**RESOLUTION NO. R16-118**

**A RESOLUTION AUTHORIZING THE MAYOR TO SIGN  
CHANGE ORDER NO. 8 WITH WILSON BROTHERS CONSTRUCTION  
FOR THE WATER TREATMENT PLANT INTAKE PROJECT  
CONSTITUTING AN INCREASE OF \$59,068.69.**

Date of Issuance: November 11, 2016	Effective Date: November 11, 2016
Owner: City of Laurel, Montana	Owner's Contract No.: FEMA: 1996-DR-MT-PW 01679
	SRF: EQ 16-1684
Contractor: Wilson Bros. Construction, Inc.	Contractor's Project No.: MT16-04
Engineer: Great West Engineering, Inc.	Engineer's Project No.: 2-07128-TO26
Project: Water Treatment Plant Intake	Contract Name: N/A

# CITY OF LAUREL, MONTANA WATER TREATMENT PLANT INTAKE CONSTRUCTION PLANS

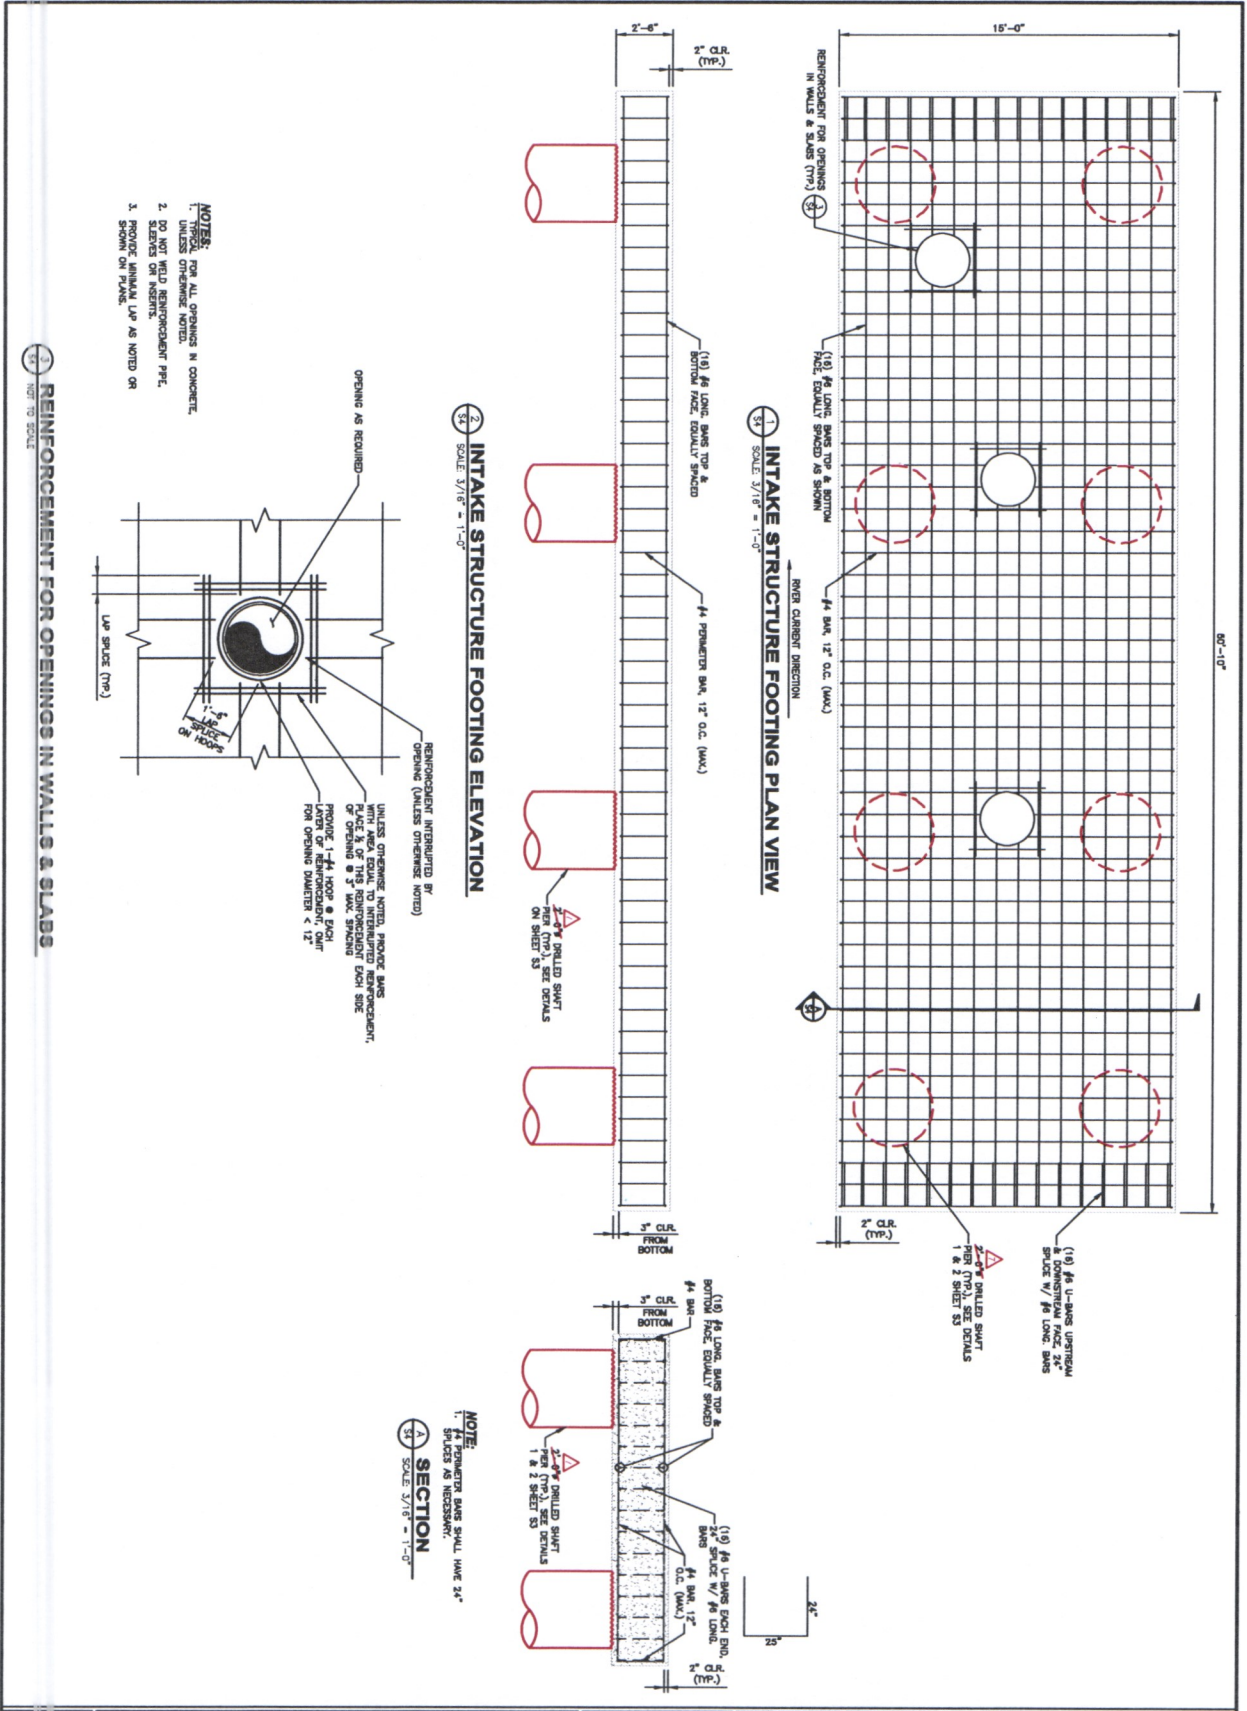
△ SHEET 75 GOB REVEAL BEDROCK ELEVATION AND DRILLED SHALT PER DEPTHS

- △ SHEET 75 GOB REVEAL BEDROCK ELEVATION AND DRILLED SHALT PER DEPTHS
- △ SHEET 76 GOB WTP BYPASS LINE ALIGNMENT PLAN & PROFILE - STA 10+00 TO STA 19+00
- △ SHEET 76 GOB BURRED WATER STORAGE TANK SITE PLAN
- △ SHEET 77 GOB BURRED WATER STORAGE TANK DETAILS AND SECTIONS
- △ SHEET 78 GOB BOOSTER PUMP AT TRANSMISSION MAIN

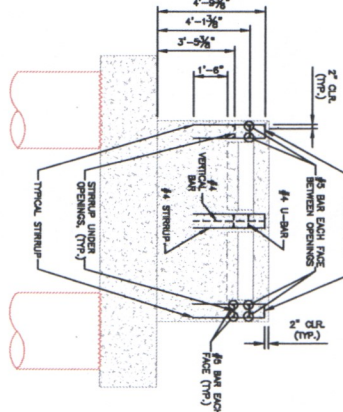
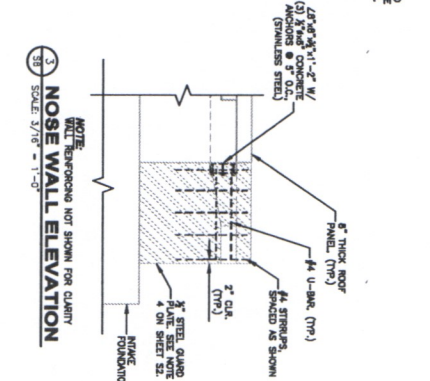
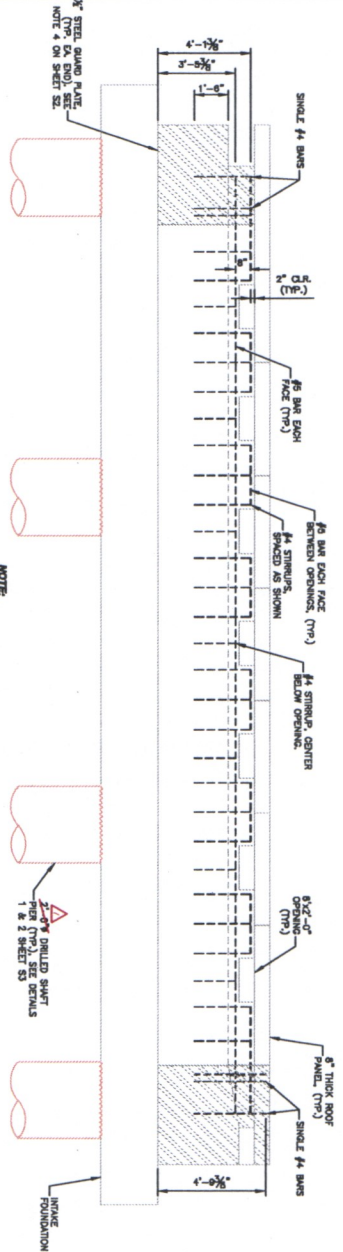
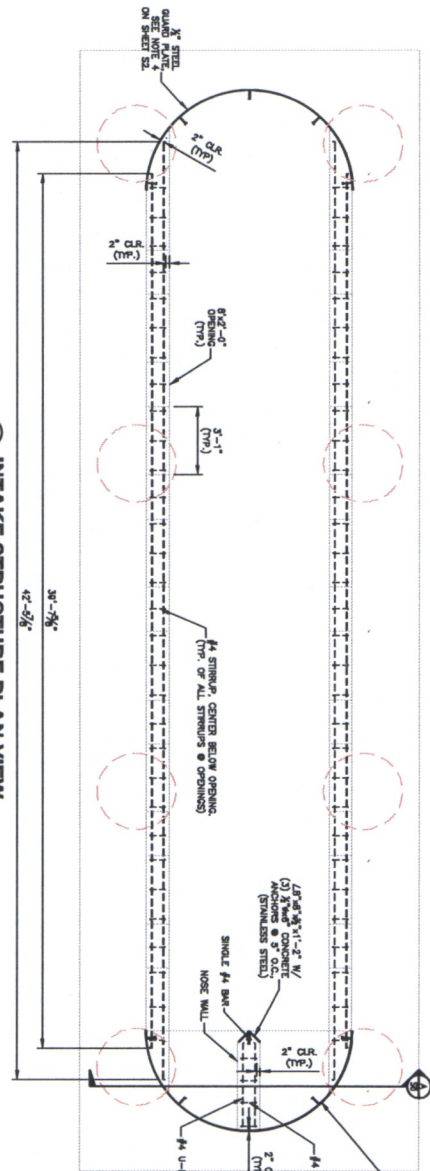
- Additional bedrock investigation during construction determined that the bedrock elevation at the intake is 3 - 8 feet lower than was anticipated during design. The deeper bedrock necessitated that the drilled shafts be lengthened and increased in diameter. In addition, the top portion of each shaft will be encased in steel. Refer to the attached Construction Plans for details of the revision.

- Add *Item No. 103A – Cased Drilled Shafts, Diameter Varies* with a quantity of 8 EA. Increase in cost = 8 EA x \$10,817.50/EA = \$86,540.00.
  - The contract quantity for *Item No. 103 – 2-ft Diameter Drilled Shafts* will be decreased from 120 LF to 0 LF. Decrease in cost = \$120 LF x \$250.00/LF = (\$30,000).

- Increase the contract quantity for *Item No. 104 – Drilled Shaft Concrete* from 14 CY to 54 CY. Increase in cost = 40 CY x \$600.00/CY = \$24,000.00.
